Comparison of proposal from ETRTO and France for Informal Annexes 8 et 9 - R117 amendm

The definition of a Virtual Lab: open points

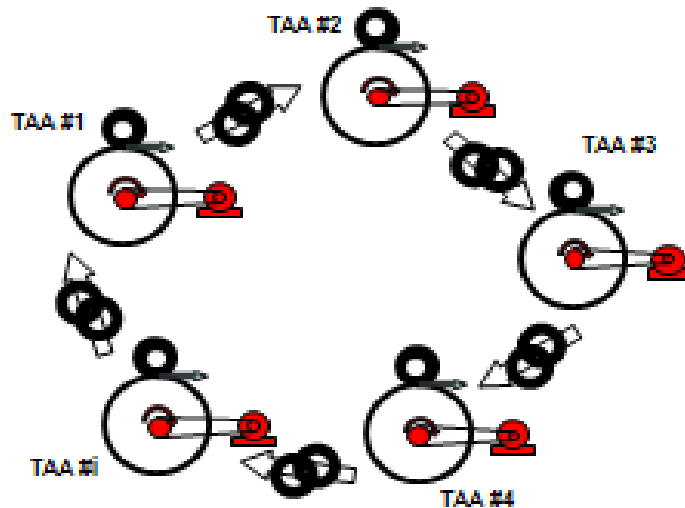
Beside the range for Cr and the way to organize the round robin test, from the comparison, it appears that both documents are almost equivalent.

The following have to be assessed:

- 1) understanding why some parts have been moved by France from Annex 8 to annex 9 (Action item from France)
- 2) for the alignment procedure, to check whether there is a possibility to merge both proposals as follow: "Repeated at least every two years and after any significant machine change or any drift. During each two years period, the set of selected tyres and their assigned values will not be changed." (Action item from France)
- 3) explanation of the content of ISO 5725 and the reason why it is needed. (Action item from France)

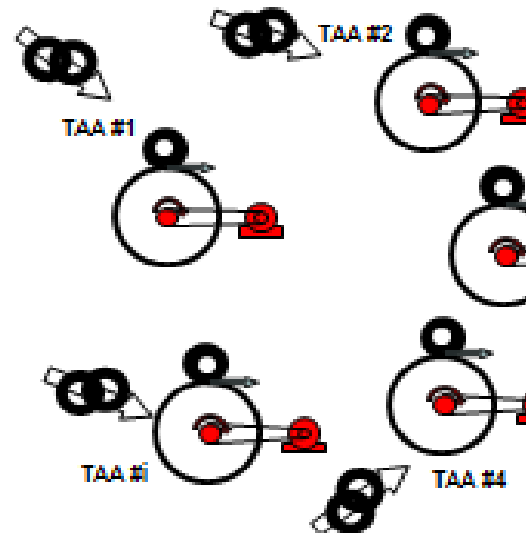
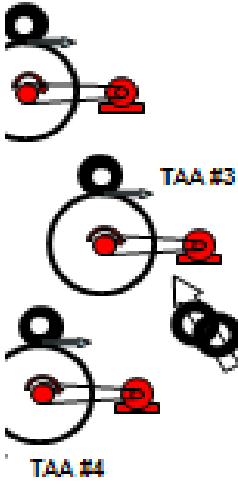
The same set of physical alignment tires circulated In Sequence for the alignment

The sets of similar alignment tires us Parallel for the alignment

There are pro/cons in the 2 possibilities in terms of accuracy, efficiency... that c
be further investigated

How the correlation works

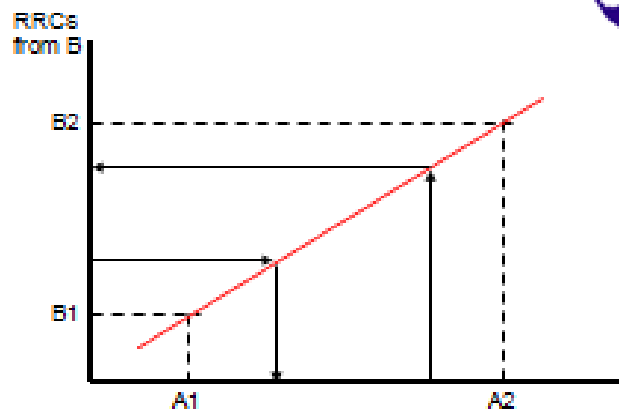
Linear regression correlation formula by which
other RRC can be aligned to the other mach

For a proper linear regression an appropriate "range"
values should be considered (e.g. 3N/kN according
ISO28580, or 1.5 ± 0.5 N/kN according to Annex 9),
depending also on the number of tyres.

Tyre Industry assessment need to be completed.
